**PERMITTEE FLORENCE COPPER, INC.'s RESPONSE TO PETITION FOR REVIEW  
FILED BY SWVP-GTIS MR, LLC AND THE TOWN OF FLORENCE**

**Southwest Value Partners' Comments on Draft Permit**

Re: Florence Copper Project  
Draft Underground Injection Control Permit R9UIC-AZ3-FY11-1

**Southwest Value Partners  
Comments on  
Draft Underground Injection Control Permit R9UIC-  
AZ3-FY11-1  
Issued to Florence Copper, Inc. for the Florence  
Copper Project  
Florence, Arizona**

Figure 1. Region 9 Exemption Guidance

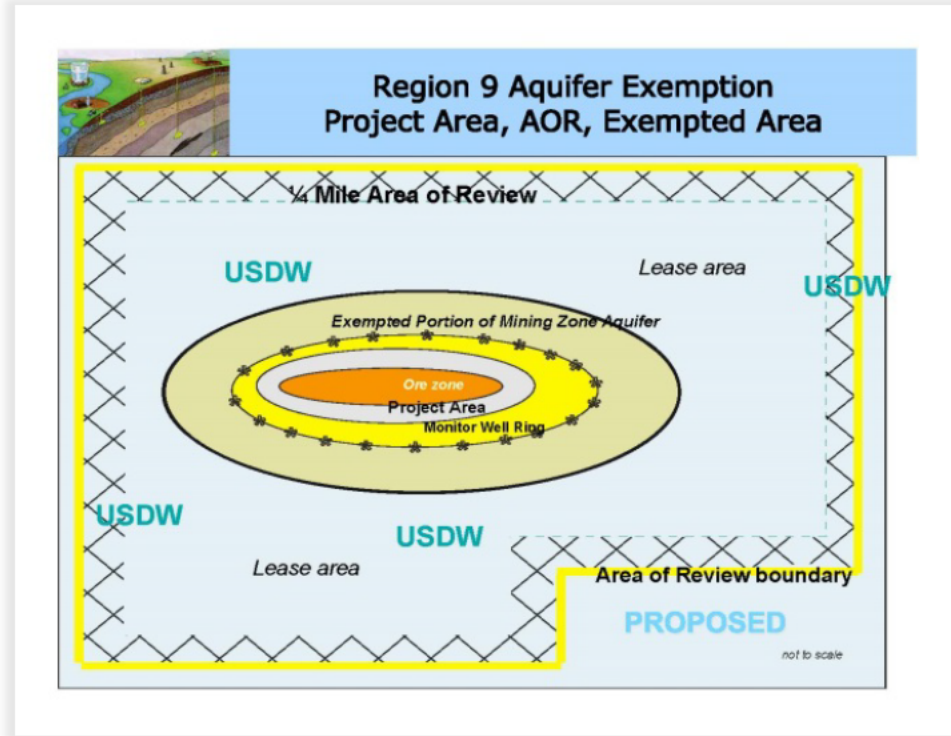
Beyond the regulations, EPA Region 9 has published guidance that requires the agency to take all aquifer exemptions very seriously. In particular, when addressing a proposed mining permit, the exempted area is to be kept *as small as possible* while still allowing mineral extraction. Appendix F provides specific references to recent EPA rule-making and permitting decisions that implement this policy. It also cites the source of the figure below. This Region 9 product that has recently been used to show an exemption is appropriate only inside the Area of Review, and not far outside the ring of monitoring wells.

The Statement of Basis for the Draft Permit claims to justify a large exemption area because there are no drinking water wells inside of it today, and existing downgradient drinking water wells are too far from the PTF to be impacted. As a matter of law, this justification is completely wrong; EPA regularly acts to protect aquifers, not just existing wells. We challenge EPA to find any legal authority for its position, or explain why it should ignore its own guidance, illustrated in Figure 1 above.

**Figure A-2: Sulfate Values in Observation Wells During BHP Pilot Test<sup>31</sup>**

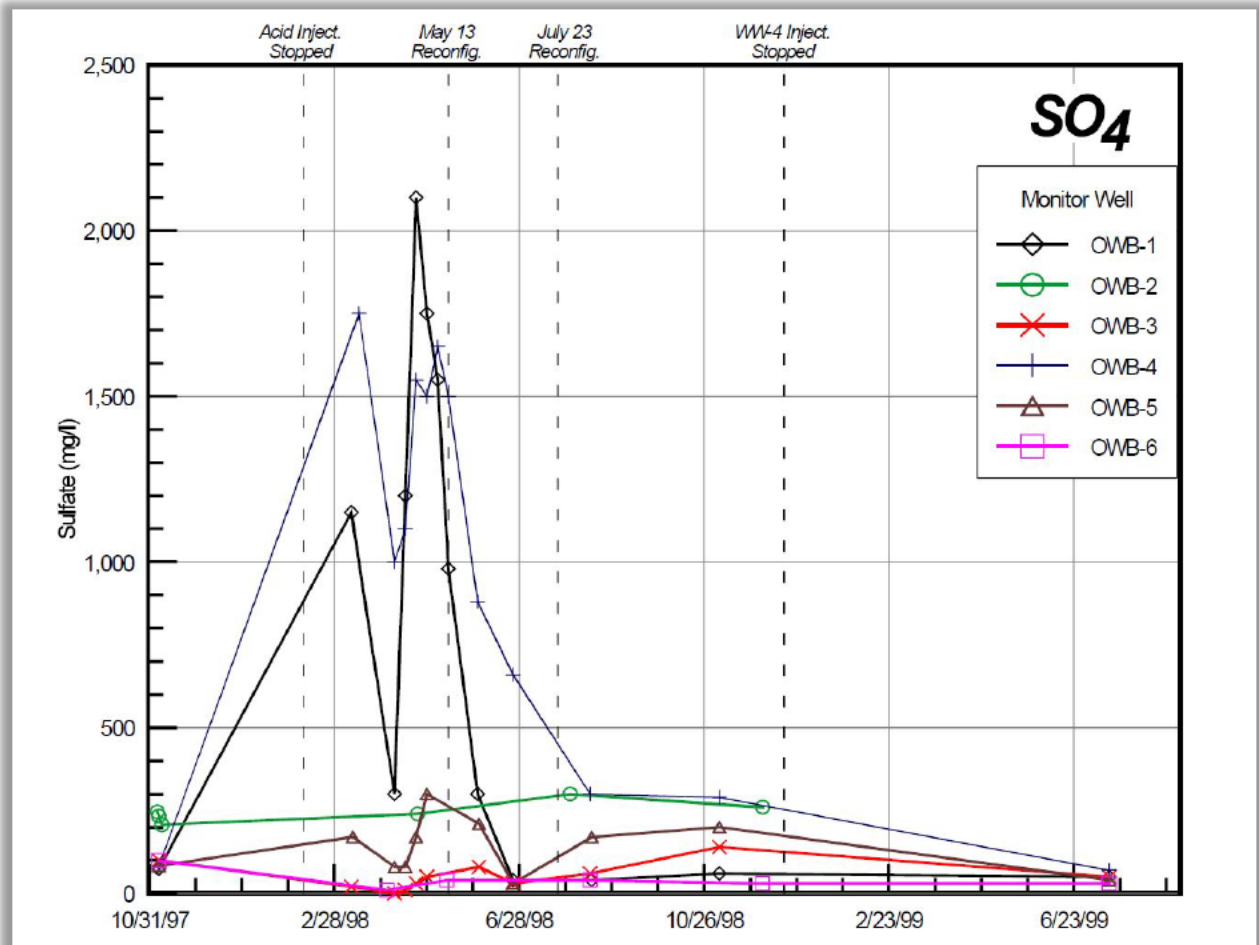
According to Dr. Wilson, the only explanation for these sulfate concentrations is that injected acid solution migrated horizontally to reach the observation wells. And this conclusion is confirmed by the pH data for these same wells, an analysis of which shows results consistent with an escape of acid solution. Review of these results would lead one to believe that injected acid solutions had also migrated beyond the observation wells completely undetected even though all permit conditions were being met.

**Figure A-3: Conductivity Difference from Background in mS/m After One Month of Acid Injection During BHP Pilot Test<sup>37</sup>**

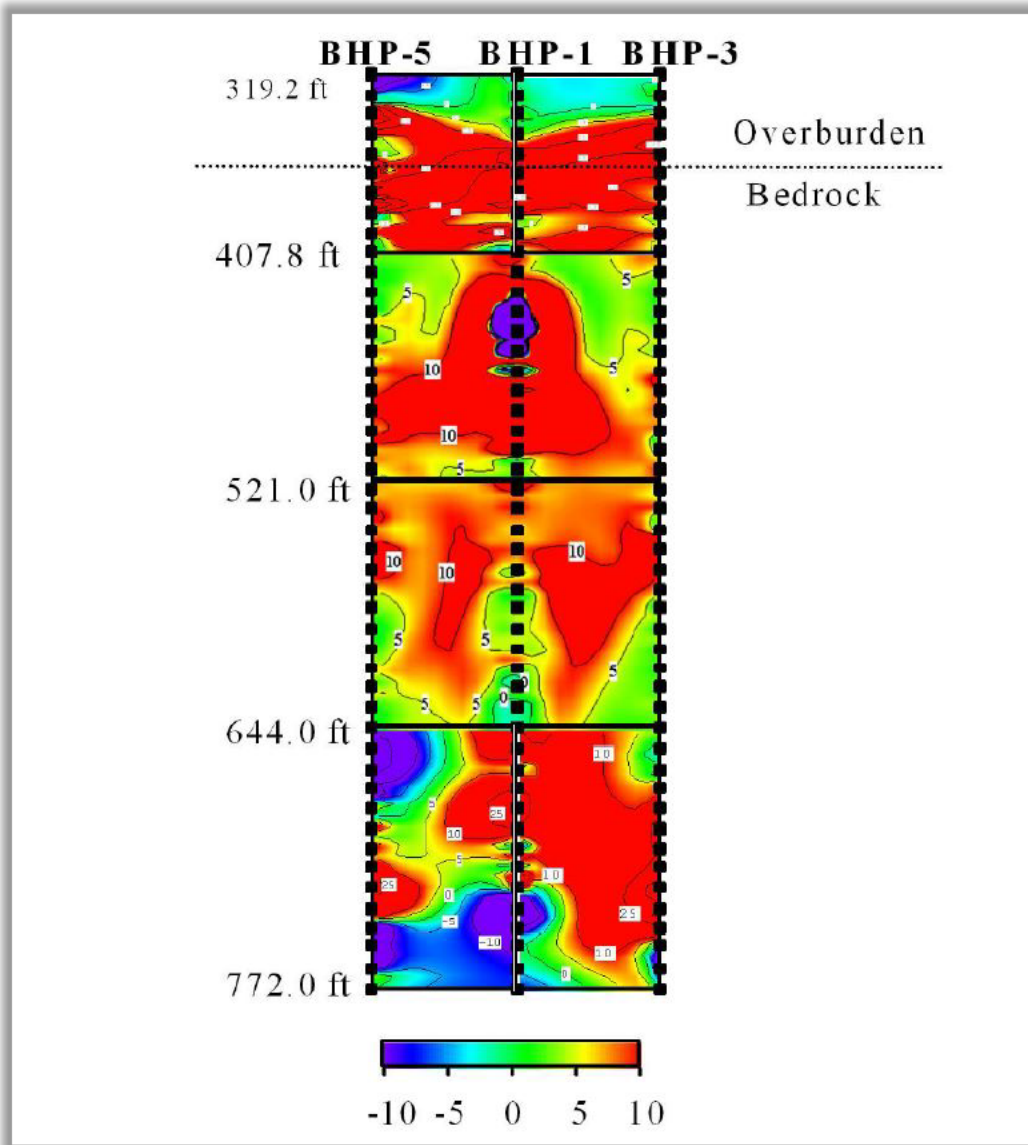
Injected acid also moved vertically into the LBFU during the BHP Pilot Test. BHP installed electrodes along the wellbore of the five injection wells at three-meter intervals. Changes in electrical resistance were measured before and after injection. Because the injected fluid had smaller resistance than formation water, zones with negative changes in resistance represented the flow paths of injected solution.<sup>32</sup> These flow paths are depicted in red in Figure A-3 below, with “overburden” representing the LBFU.

These measurements show that BHP’s acid solution migrated vertically 20 feet into the LBFU. This was predicted by BHP<sup>33</sup> and allowed by BHP permit. And this figure is based on acid migration after only 30 days of injection. Region 9 should anticipate greater impacts to the LBFU from the FCI’s more than 400-day PTF. The damage will be even worse from a commercial project where multiple mine blocks will inject millions of gallons of acid over many years.

**Figure A-5: Recommended Location of Additional Observation Wells**

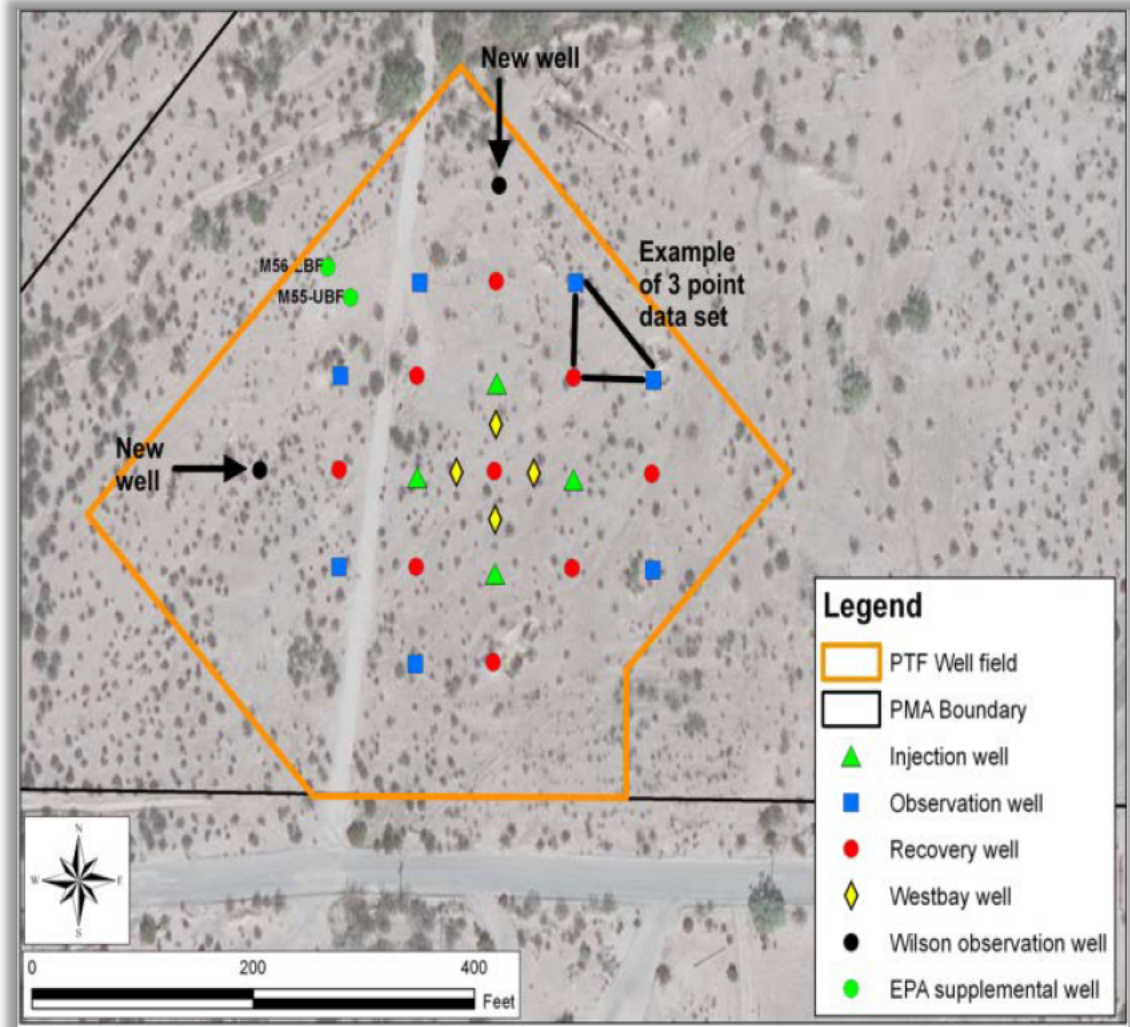
flows in these directions. Consideration of the BHP Pilot Test results mandates that two additional observation wells be installed as depicted by Dr. Wilson in Figure A-5.

**Figure I-3. Calculation of Sulfate Balance**

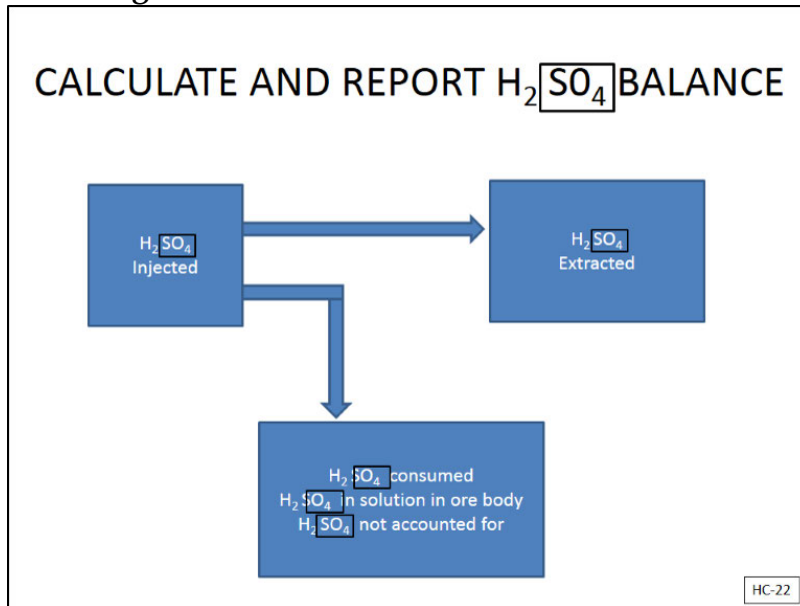
Instead, a meaningful permit must require FCI to calculate and report an acid balance or a sulfate balance.<sup>199</sup> As depicted in Figure I-3, all sulfuric acid injected in the aquifer must end up in one of four places: (1) extracted fluids; (2) consumed in chemical reactions in the oxide zone; (3) solution that remains in the ore body; or (4) fluid that has escaped the well field. By requiring FCI to calculate and report an acid or sulfate balance, EPA can determine whether FCI has properly accounted for all of the acid that it injected into the aquifer. A failure by FCI to account for all of the acid that it injected shows that FCI has not maintained hydraulic control.

Figure I-4. BHP Gradient Data

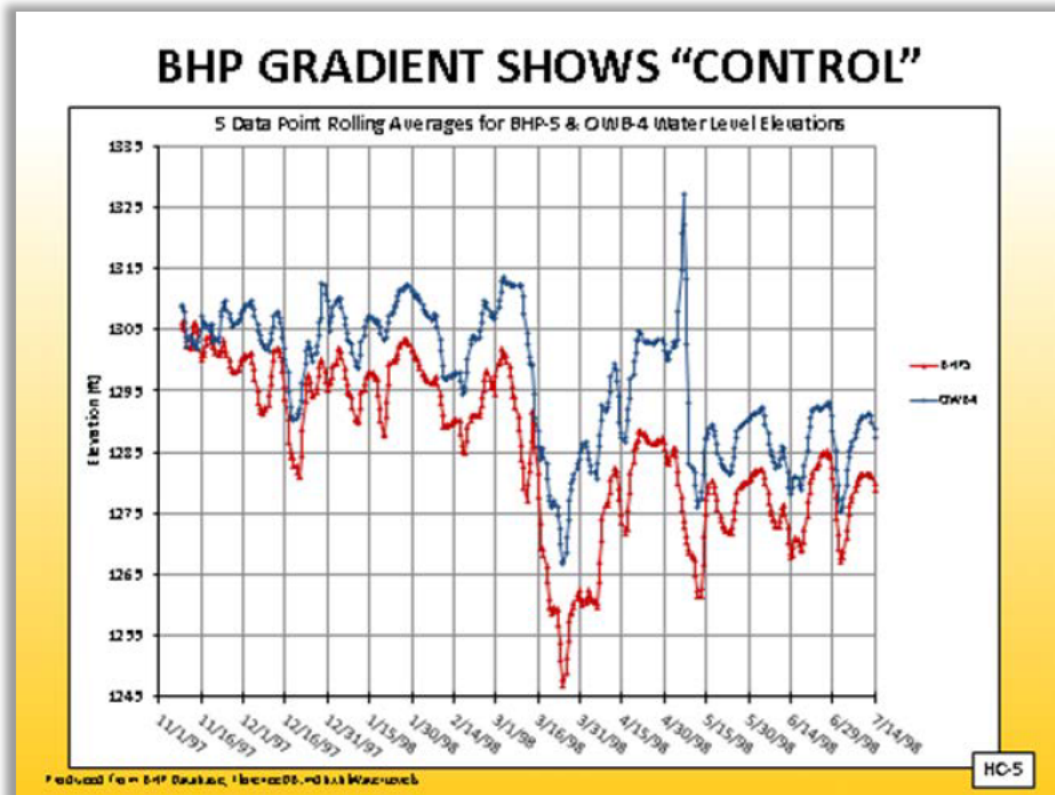
Based on BHP Pilot Test database produced by FCI, Dr. Wilson visually depicted the gradient data for BHP-9 and OWB-4, the recovery-observation well pair in the southwest corner of the BHP Pilot Test well field. In Figure I-4 below, the blue line depicts the outside, observation well water level and the red line displays the inside recovery well water level. The observation well's water level is higher than the recovery well's in all cases, indicating there was an inward hydraulic gradient. But as has already been noted, OWB-4 experienced numerous high sulfate concentrations in March and April 1998, indicating horizontal acid escape toward that observation well.

Thus, BHP complied with the water gradient permit condition in its permit during the same period when a known acid escape occurred. This demonstrates that a measured inward gradient is not enough to demonstrate hydraulic control.

Figure I-5. Well Inefficiencies in a Pumping Well

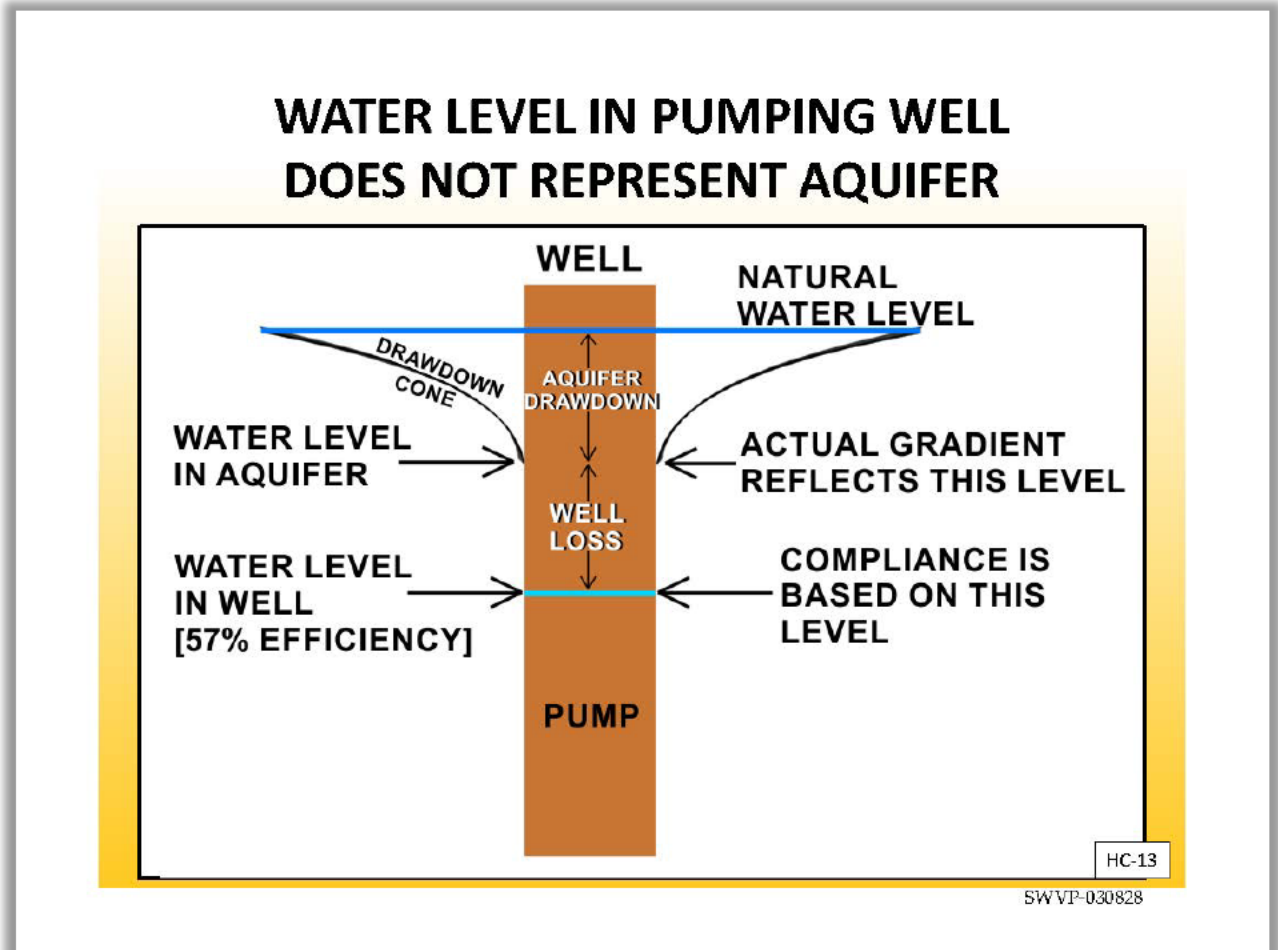
Third, the inward gradient unreasonably is based on measurement of water levels in FCI's wells, which are affected by well inefficiencies, instead of water levels in the aquifer. As depicted in Figure I-5 below, well inefficiency occurs because water levels are lower inside a pumping well than the water levels of the actual groundwater aquifer that it is intended to reflect.<sup>221</sup> As reflected in Figure I-6 below, this issue is well understood by EPA and should have been incorporated into the permit requirements.<sup>222</sup>
